# Access Compliance Report

## Public Rights-of-Way

Intersection ID: 27815	Main Street: BRAID_HILLS_DR	Cross Street: PROVIDENCE_COUNTRY_CLUB_DR	Location: SE
ADA ID: F474E8E8F180	Ramp Type: BlendTrans2	Initial Pass/Fail: Fail	Overall Compliance: No
Severity Score: 12.5			
Codes/Mitigation Info/Possible Solution		Field Measurements/Component Compliance

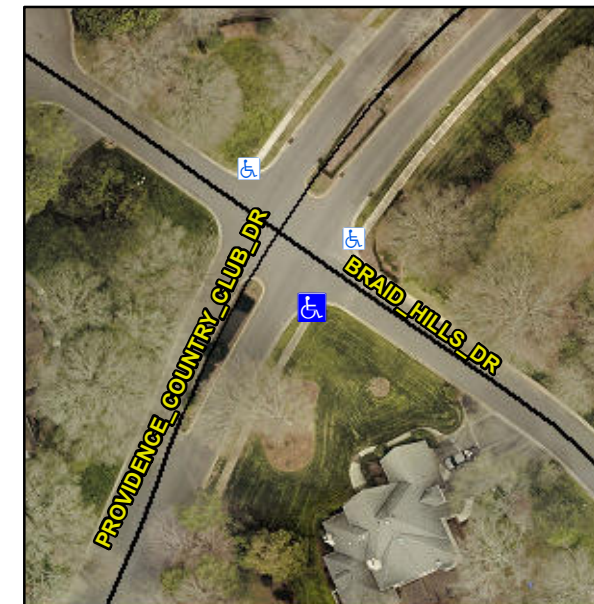
**Not Found, R304.5.3**

Compliance	Description	Data	Compliance	Description	Data
N/A	Ramp Length (in)	30.0	Yes	BlendTrans Slope (%)	3.6
Yes	Ramp Width (in)	48.0	No	BlendTrans XSlope (%)	6.0
N/A	Flare Type LT	N/A	N/A	Flare Type RT	N/A
N/A	Flare Slope LT (%)	N/A	N/A	Flare Slope RT (%)	N/A
N/A	Flare Traversable LT?	N/A	N/A	Flare Traversable RT?	N/A
N/A	Landing Length (in)	N/A	N/A	DWS Provided?	N/A
N/A	Landing Width (in)	N/A	N/A	DWS Contrast?	N/A
N/A	Landing Slope (%)	N/A	N/A	DWS Length (in)	N/A
N/A	Landing X Slope (%)	N/A	N/A	DWS Full Width?	N/A
N/A	Landing Curb? (Y/N)	N/A	N/A	DWS Offset (in)	N/A
N/A	Shared Landing?	N/A			
N/A	Gutter Ponding?	N/A	N/A	Gutter Slope (%)	N/A
N/A	Gutter Lip Ht (in)	N/A	N/A	Gutter X Slope (%)	N/A
N/A	Painted X Walk1?	No	N/A	Painted X Walk2?	N/A
	X Walk 1 Direction	To NE		X Walk 2 Direction	N/A
	X Walk 1 Width (in)	N/A		X Walk 2 Width (in)	N/A
	X Walk 1 Slope (%)	4.6		X Walk 2 Slope (%)	N/A
	X Walk 1 X Slope (%)	0.7		X Walk 2 X Slope (%)	N/A

N/A	Ramp inside XWalk1?	N/A	N/A	Ramp inside XWalk2?	N/A
	Road Slope (%)	0.7		Clear Space?	N/A
	Road X Slope (%)	4.6	N/A	Clear Space to XWalk (in)	N/A
N/A	Any Obstructions?	N/A	N/A	Storm Grate/Utility Hazard?	N/A
	Obstruction Type			Storm Grate/Utility Type	
		N/A			N/A
			Yes	Surface Condition? (G/P)	Good
			No	Curb Slope (%)	9.1

**Remove & Replace Curb Ramp With Two New Directional Ramps or Equivalent.**
